METROPOLITAN PLANNING COMMISSION

STAFF REPORT

Subject: Variance for Development Plan

Address: 1623 Staley Avenue

Variance Exhibit from Applicant

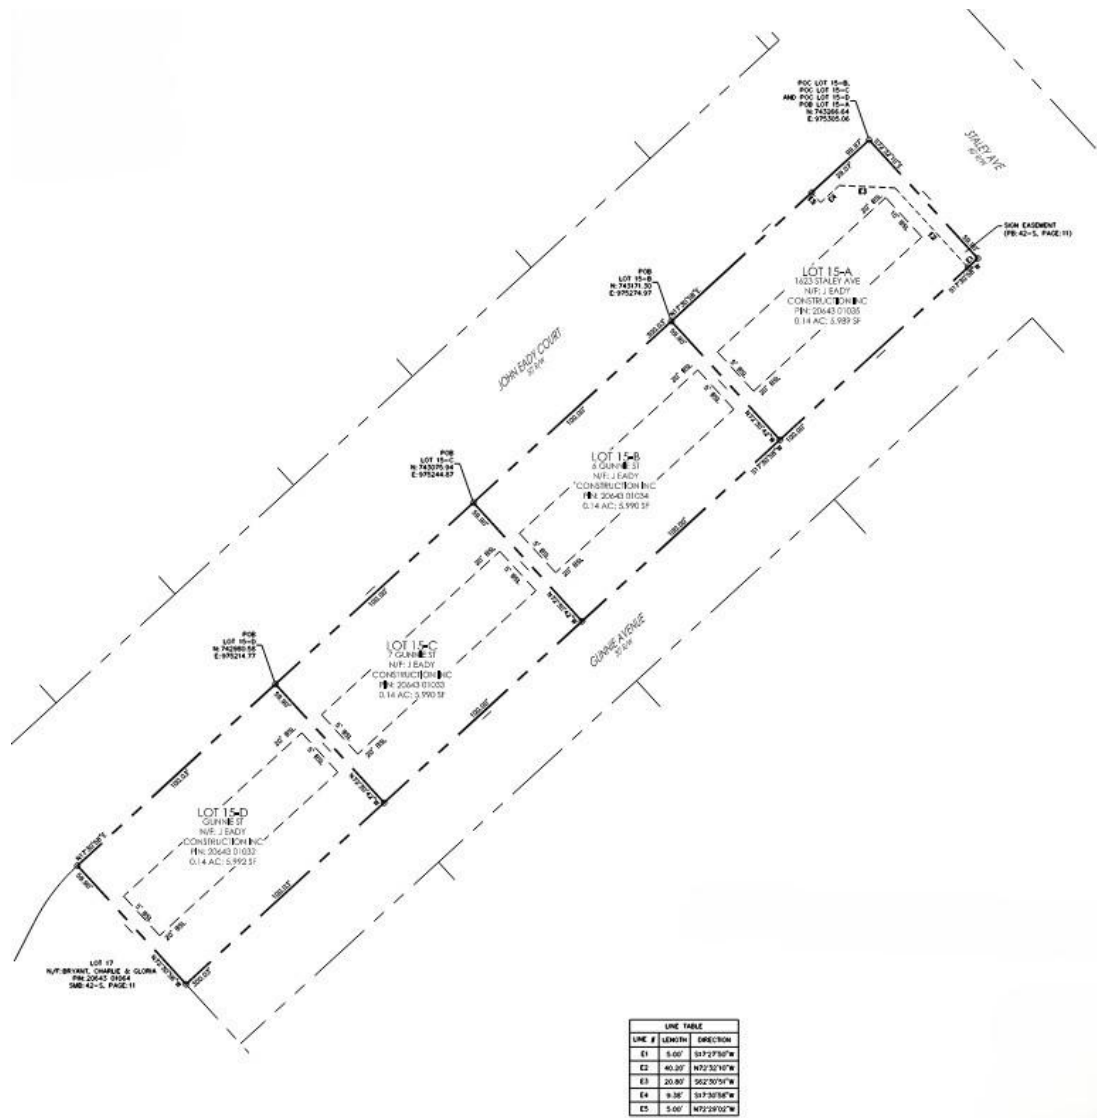
- 4) The applicant has provided a variance exhibit showing the current setbacks and proposed setback variances. In addition to reducing the front and rear setbacks to 10', the garage would have its own setbacks of 20-ft front and 20-ft rear. Essentially the attached garage portions of the house would maintain the existing setback guidelines with the Livable Areas benefiting from the setback relief. See the image below.

Setback relief (Lots 15-A, 15-B, 15-C):

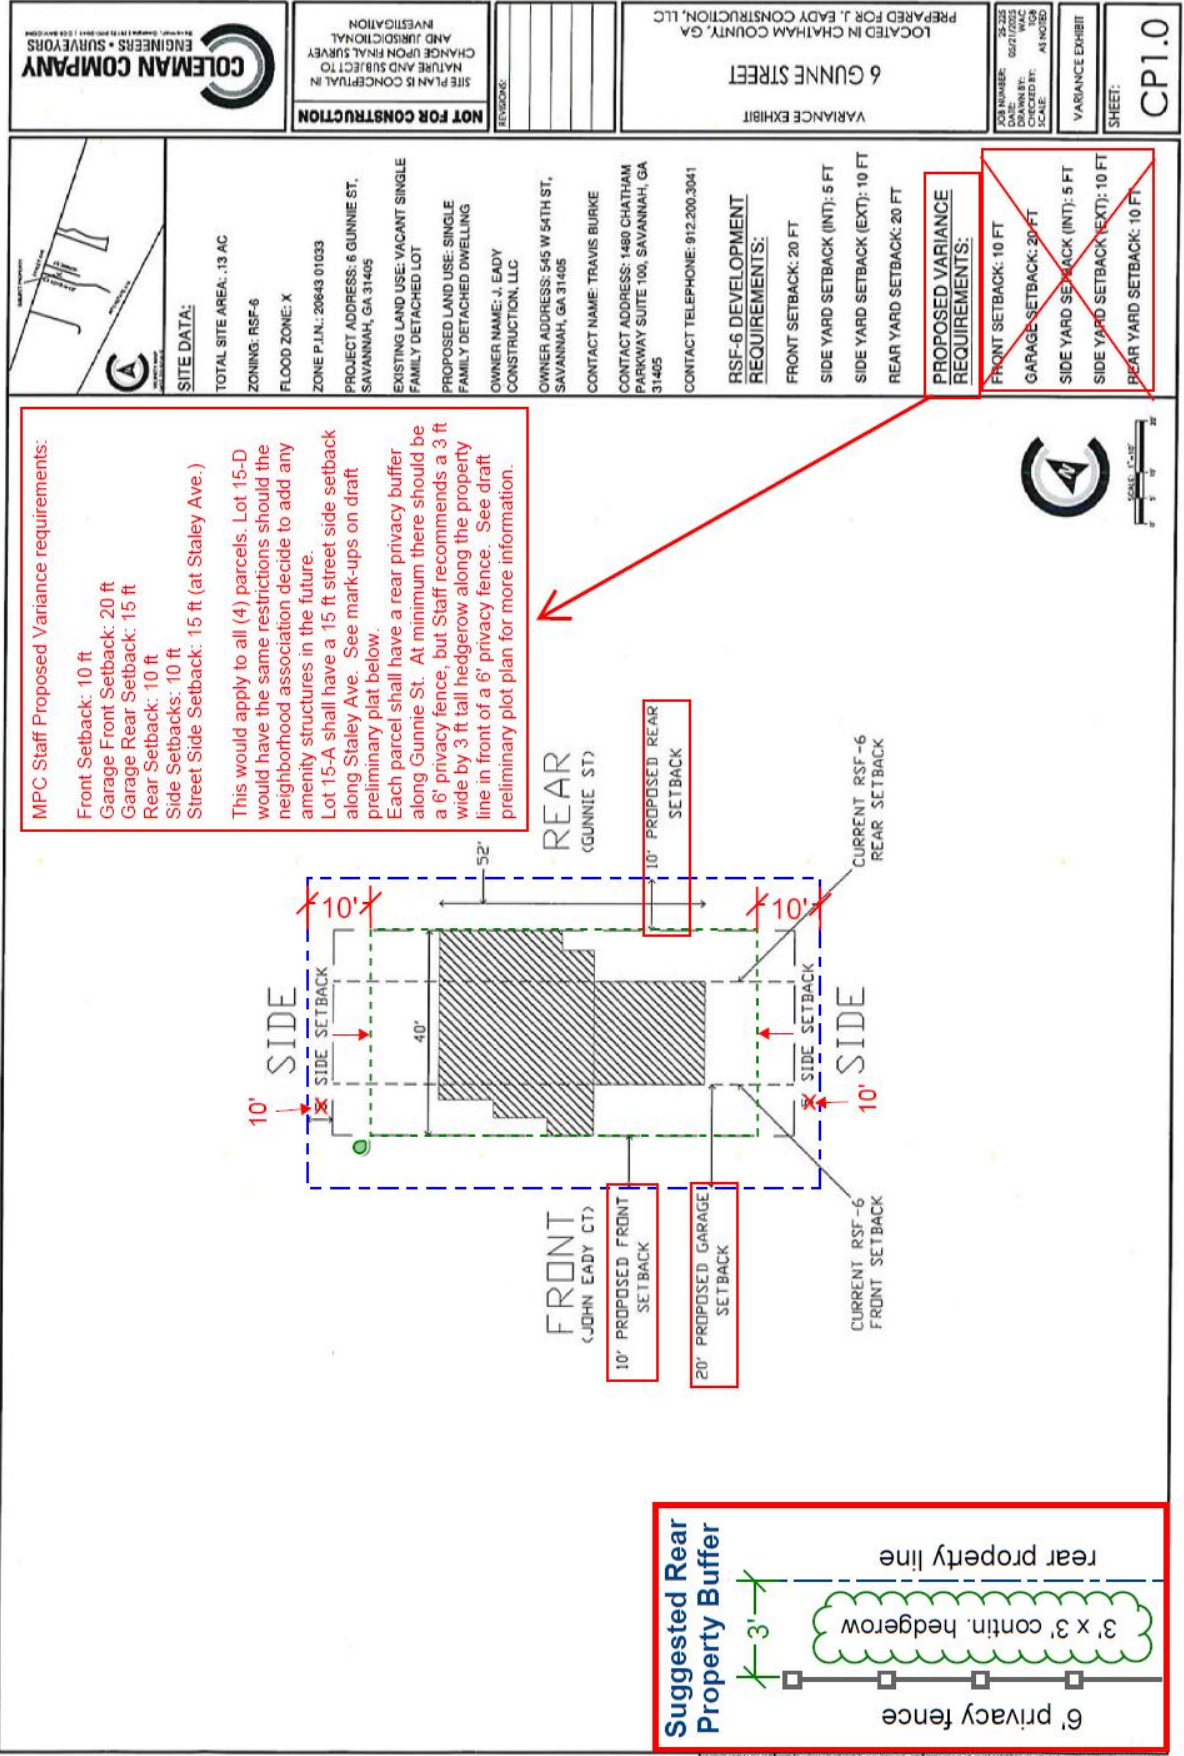
MPC Staff recommends **approval** of front and rear setback relief for lots 15-A, 15-B, and 15-C in accordance with the following stipulations and accompanying *MPC Staff exhibits*:

1. Reduce the front setback from 20-foot to 10-foot for habitable areas.
2. Maintain the 20-foot front setback for attached garage areas.
3. Reduce the rear setback from 20-foot to 10-foot for habitable areas.
4. Create a 15-foot rear setback for attached garage areas.
5. For lot Revise the side setbacks to be 10-foot (interior) and 15-foot street (along Staley).

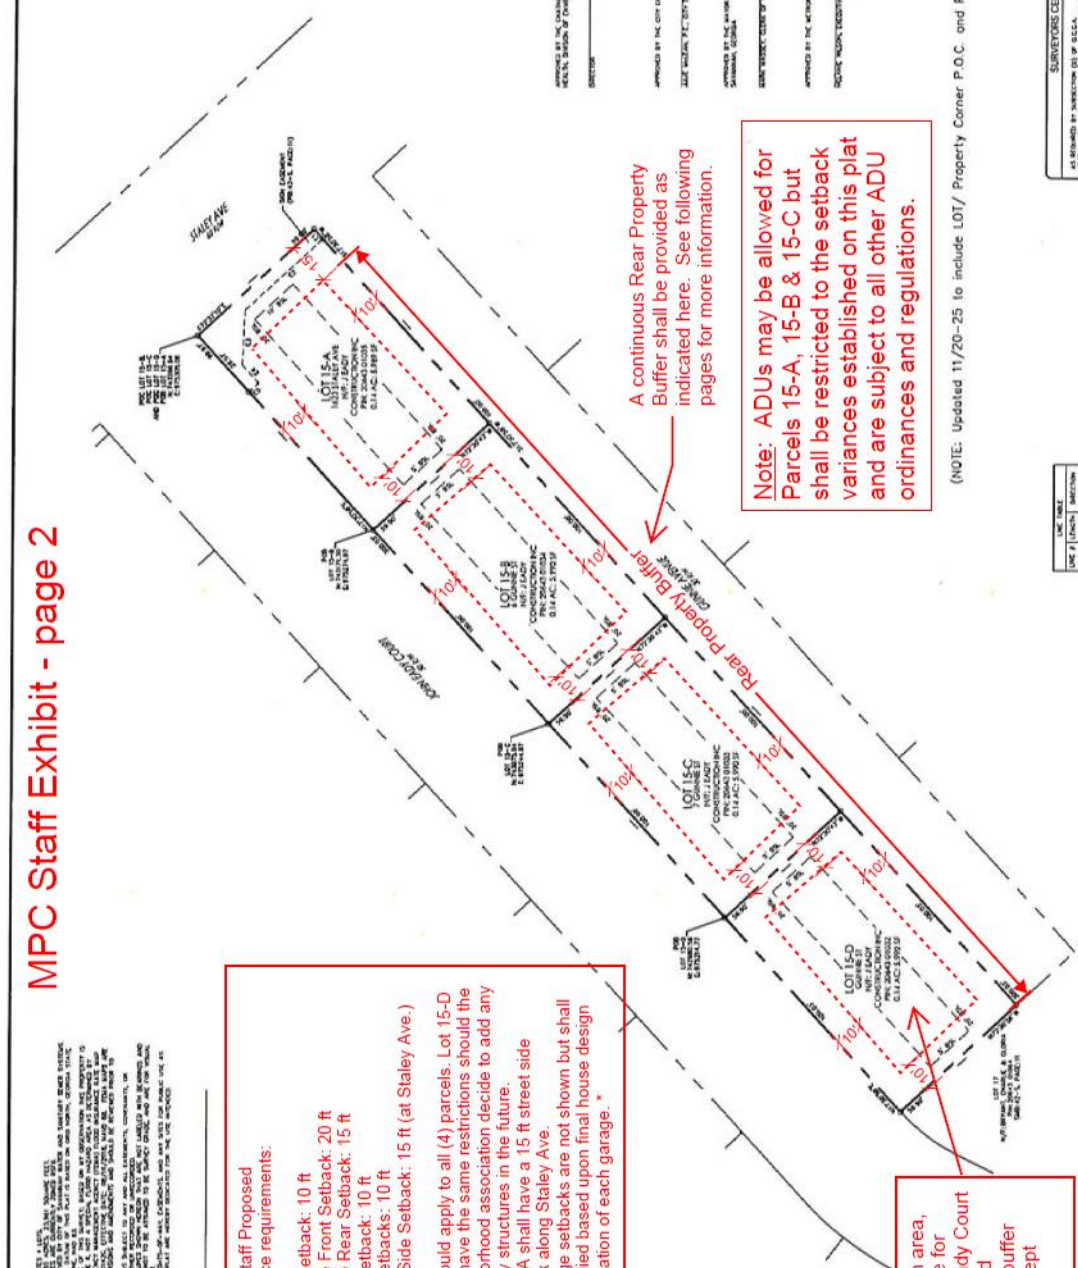
This would apply to all (4) parcels. Lot 15-D would have the same restrictions should the neighborhood association decide to add any amenity structures in the future.

Lot 15-A shall have a 15 ft street side setback along Staley Ave.

Garage setbacks are not shown but shall be applied based upon final house design and location of each garage. *

A continuous Rear Property Buffer shall be provided as indicated here. See following pages for more information.

Note: ADUs may be allowed for Parcels 15-A, 15-B & 15-C but shall be restricted to the setback variances established on this plat and are subject to all other ADU ordinances and regulations.

Front Setback: 10 ft
Garage Front Setback: 20 ft
Garage Rear Setback: 15 ft
Rear Setback: 10 ft
Side Setbacks: 10 ft
Street Side Setback: 15 ft (at

MPC Staff Exhibit - page 3

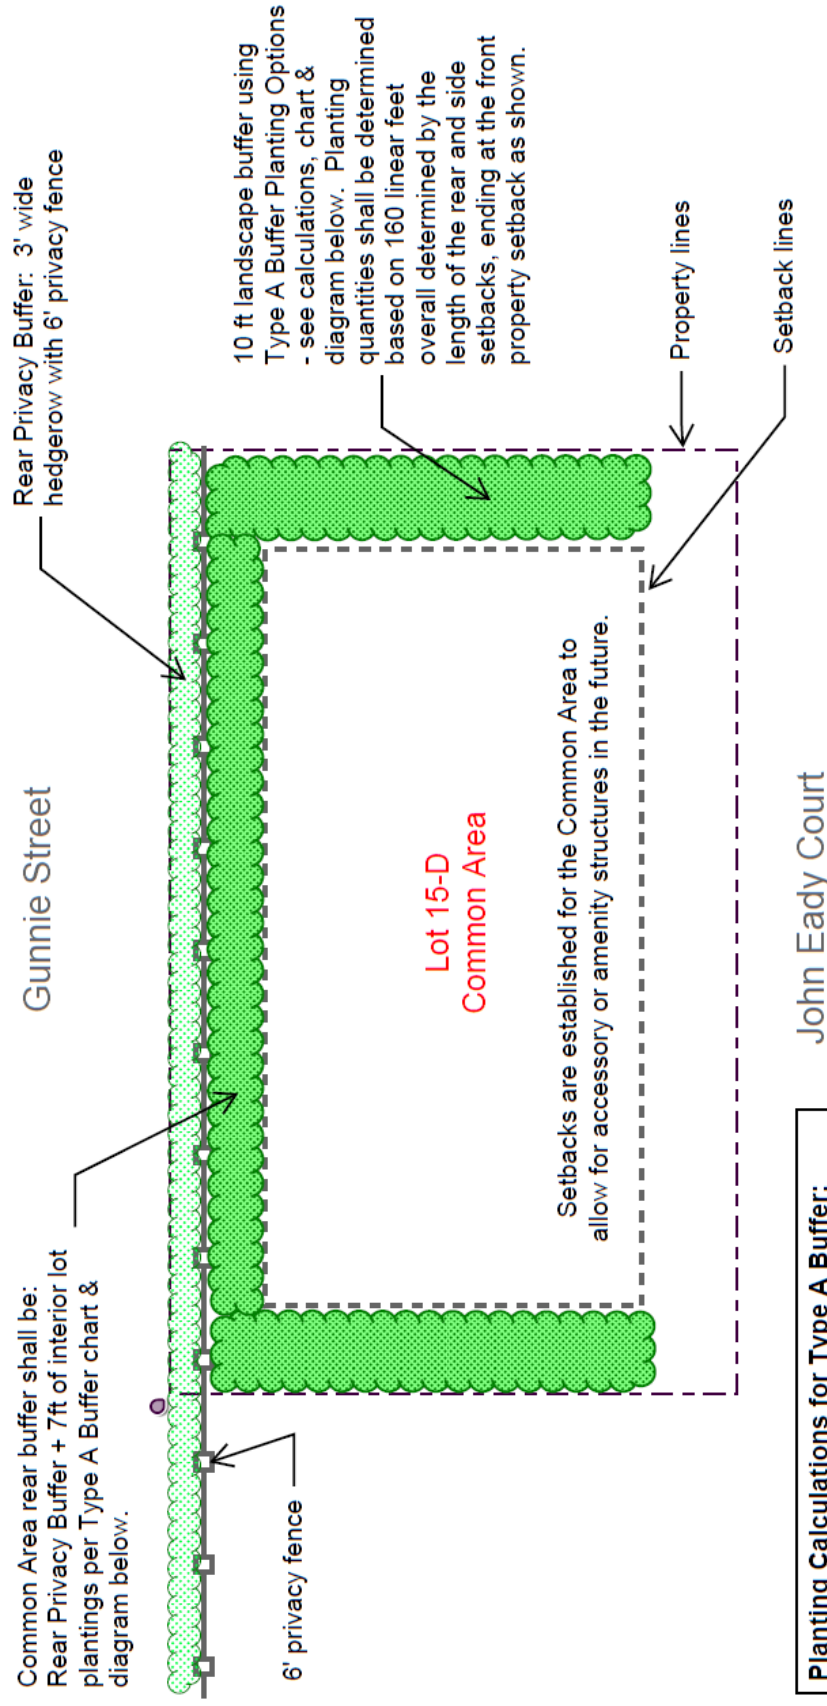
Planting Calculations for Type A Buffer:

Half of the plantings required for the 20 ft buffer with No fence/wall: (see chart/diagrams below)

Per 100 LF:

2 large trees	x 1.6 (for 160 LF) = 3
3 understory trees	x 1.6 (for 160 LF) = 5
20 shrubs	x 1.6 (for 160 LF) = 32
